Product Change Notice (PCN)

Subject: Add Alternate Fab Location

5PB1102PGGI/5PB1102PGGK/5PB1104PGGI/5PB1104PGGK

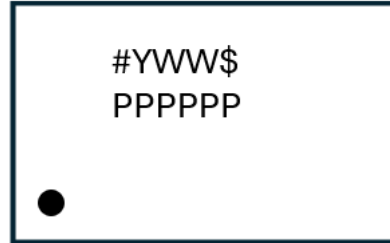
- Line 1: Y = Last digit of the year
 - WW = Workweek
 - \$ = Single Char assembly code Line
- Line 2: Truncated Product Name

5PB1102PGGI/5PB1102PGGK/5PB1104PGGI/5PB1104PGGK

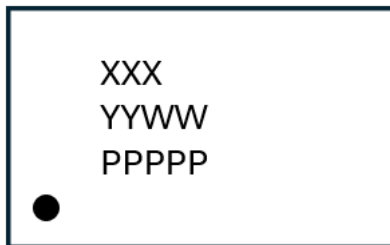
- Line 1: # = Device stepping
 - Y = Last digit of the year
 - WW = Workweek
 - \$ = Single Char assembly code Line
- Line 2: Truncated Product Name

9DBL0255NLGI

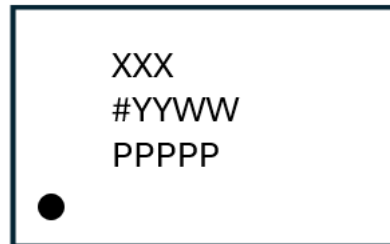
- Line 1: XXX is last 3 digits of assembly lot no
- Line 2: YY = last 2 digit of year
 - WW = Workweek
- Line 3: Truncated Product Name

- Line 1: XXX is last 3 digits of assembly lot no
- Line 2: # = Device stepping
 - YY = last 2 digit of year
 - WW = Workweek
- Line 3: Truncated Product Name
